PITTS AVIATION ENTERPRISES, INC.

SERVICE BULLETIN NO. 7

PURPOSE: To prevent failure of the horizontal stabilizer leading edge tube.

2-3100-25 F.W.P.

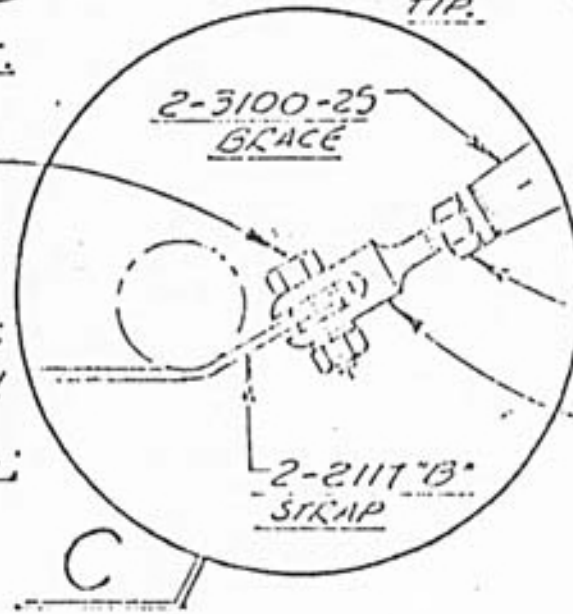
AN3-TA BOLT (TOP ON TOP); AN960-116 L WASH (BETWEEN TOP OF STRAP & FORK); AN960-116 (BETWEEN BOTTOM OF STRAP & FORK); AN960-416; AN965-428 NUT.

AN3-13.1
 AN960-10
 AN365-10.2

AN316-4

AN161-32 RS FORK

7. Install 2-3100-24 and -25 (right and left) brace tubes as follows:

a) Check to be sure the tube is being installed on the correct side of the airplane by aligning the brace tube between the 2-3100-23 bushing lower end, (installed in step 4. above), and the fork in the butterfly fitting, (installed in step 5. above), and checking that the bend of the upper end of the brace tube is parallel to the stabilizer lower surface while the tube is streamlined fore and aft, with the sharper radius of the tube cross section to the rear. Then, with the AN316-4 check nut screwed all the way onto the AN161-32 RS fork, screw the lower end of the brace tube onto the fork, until the hole in the upper end of the brace tube is aligned with the hole through the 2-3100-23 bushing.

b) Now insert the AN3-13A bolt, with the bolt head up, through the 2-3100-23 bushing and the hole in the brace tube upper end. Install AN960-10 washer and AN365-1032 nut. Then, at the lower end of the brace tube, tighten the AN316-4 nut on the fork against the end of the brace tube. NOTE: Adjustment is provided at the lower end of the brace tube so that when it is installed there is neither a tensile nor a compressive strain on the tube. In the event the adjustment provided is not sufficient, it is permissible to grind or file approximately 3/16 inch off the protruding end of the threaded bushing which is welded into the lower end of the brace tube at the factory. Do not cut the threaded bushing off any further than the end of the brace tube itself.
